CITY PLAN COMMISSION STAFF REPORT

Project Name
Emmanuel Science and Technology Center

Request
CD-CPC-2025-00037
Area Plan Amendment
CD-CPC-2025-00008
Rezoning without Plan
CD-CPC-2025-00004
Development Plan – Nonresidential

Development Plan Application Resubmittal 001
 Kansas City, MO: City Plan Commission
 02.14.2025

Emmanuel Science & Technology Center
 2418 Swope Parkway, Kansas City, MO 64130
LANDSCAPE PLAN

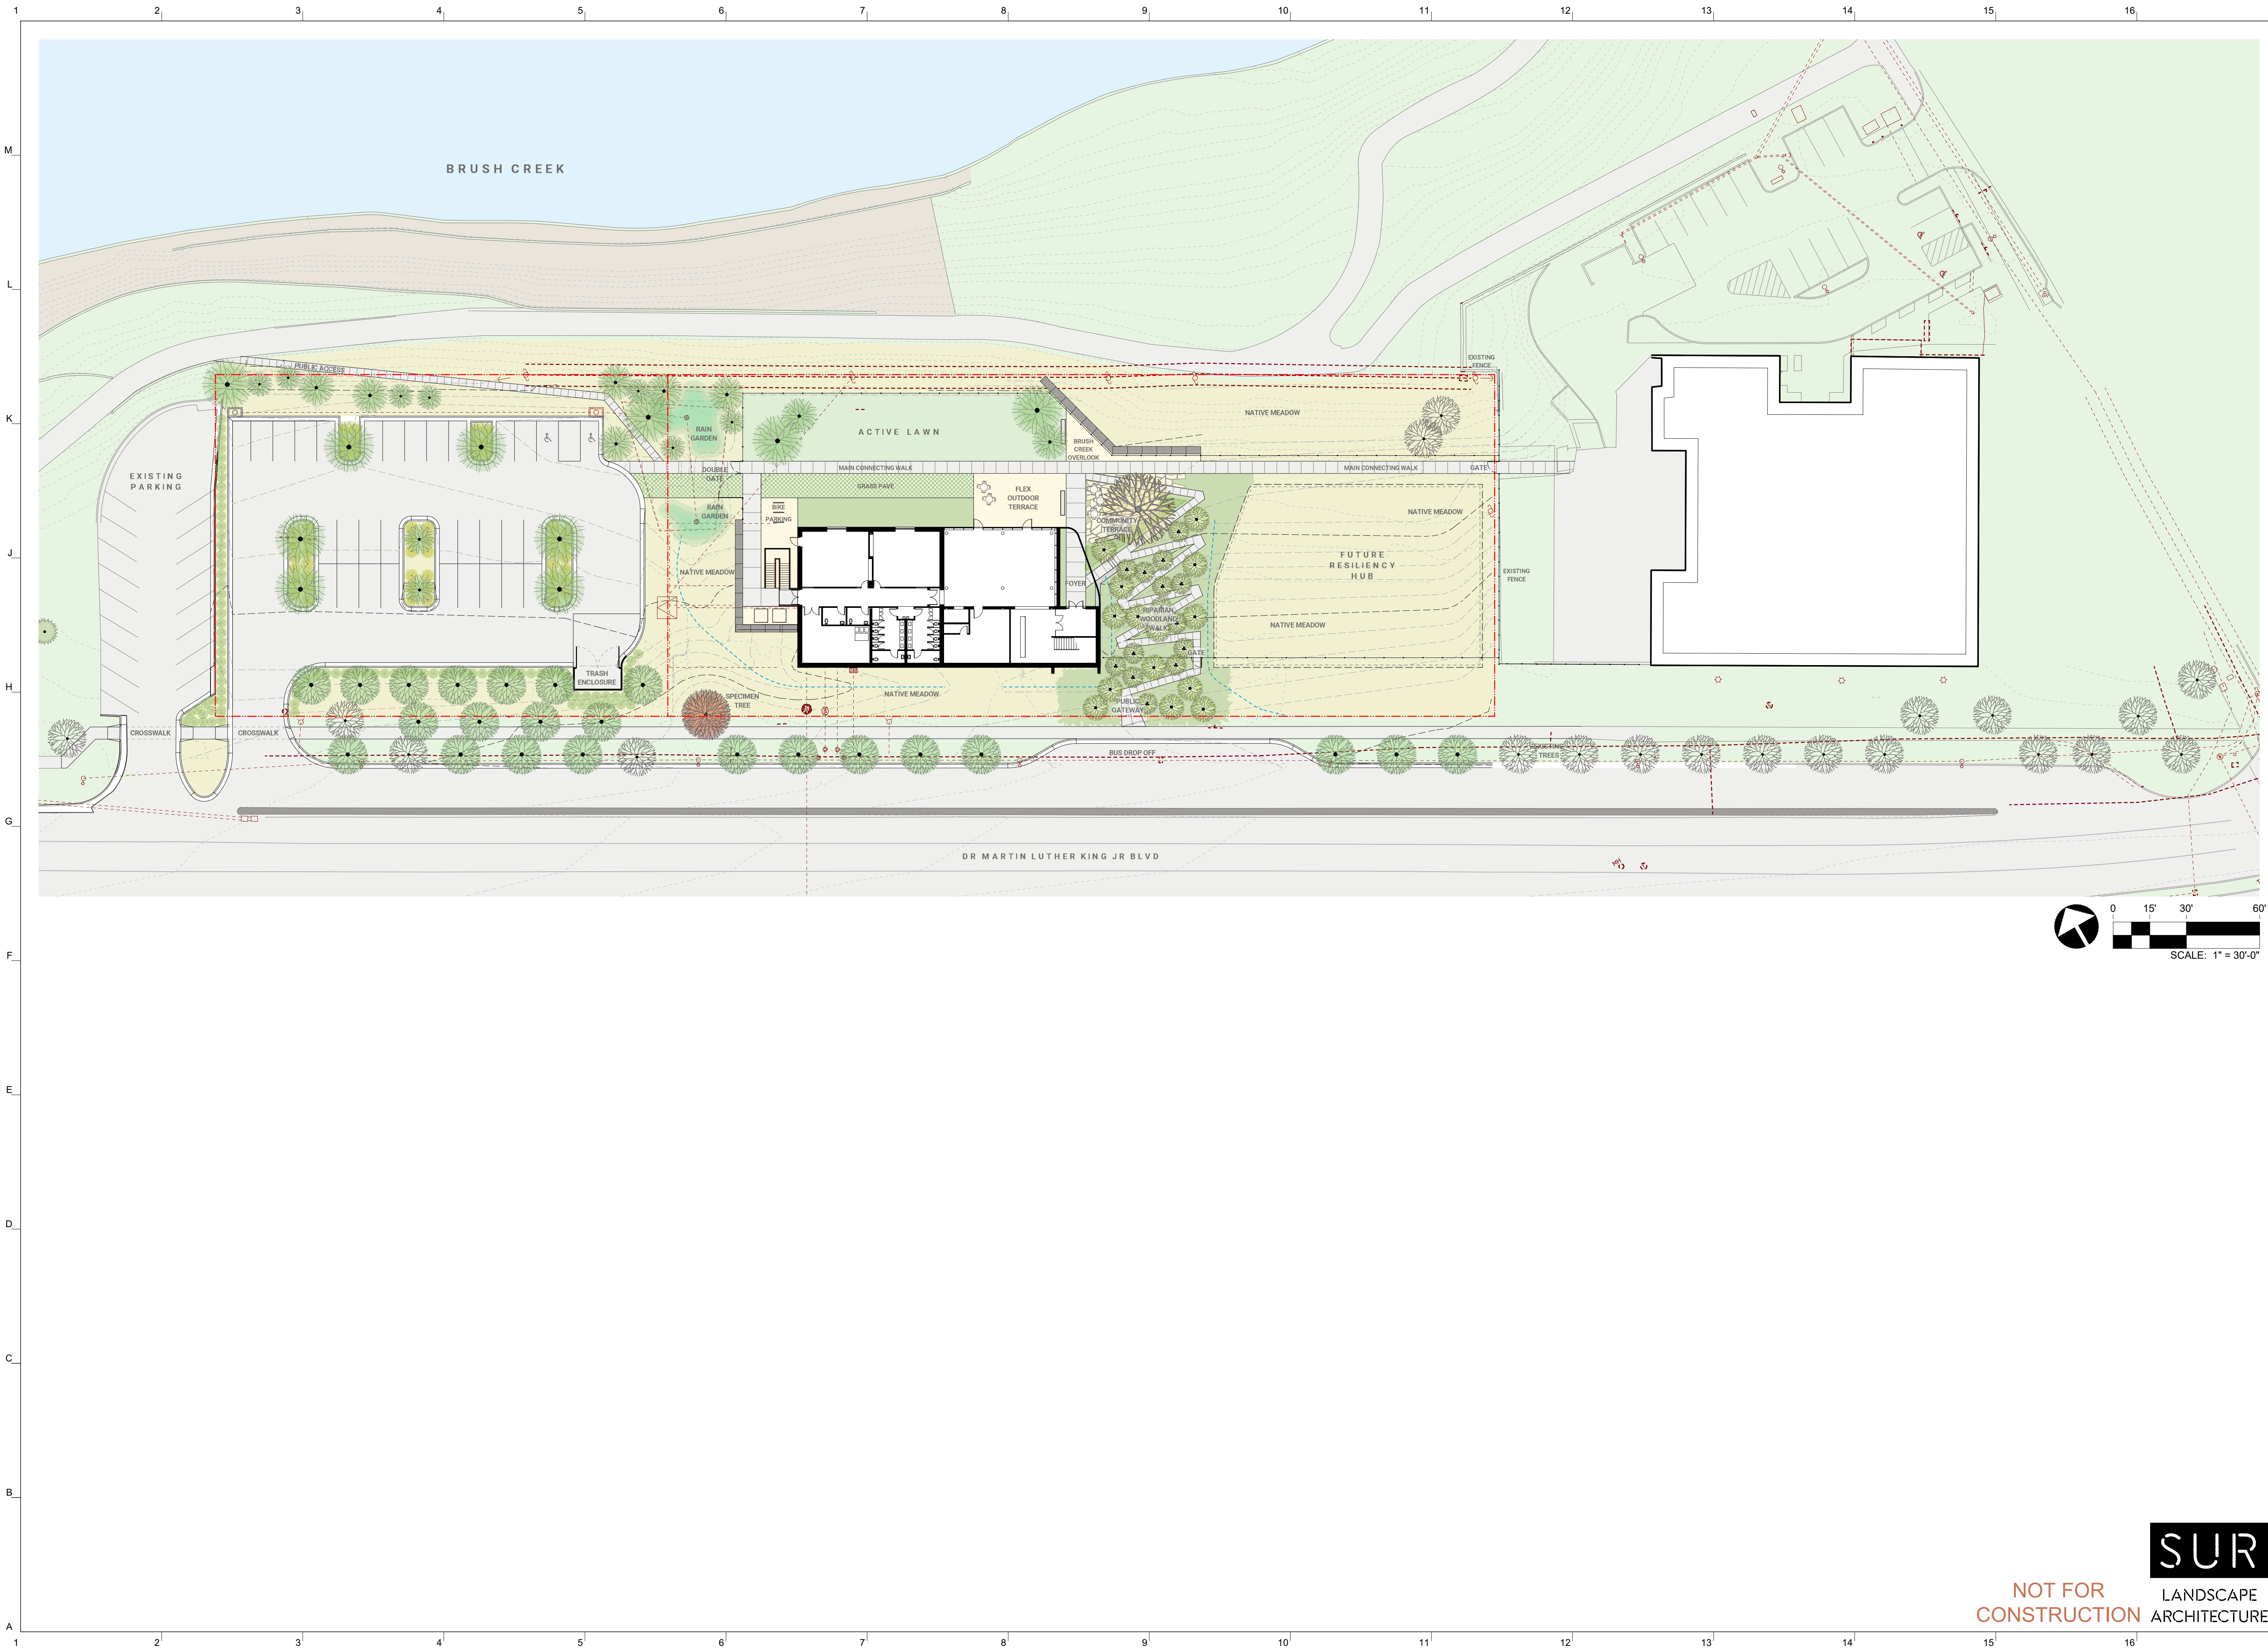
Variance 4 – A variance to 88-425-03-C. (1) – At least one street tree is required for each 30 feet of street frontage.

Proposed landscaping is currently not in conformance with the requirements as set forth in Section 88-425 of the Zoning and Development Code. The applicant will seek a variance to the required amount of street trees or revise plans prior to ordinance request.

6. All signage shall conform to 88-445 and shall require a sign permit prior to installation.
7. That prior to recording the Final Plat the developer shall upload and secure approval of a Street Tree Planting Plan from the City Forester.
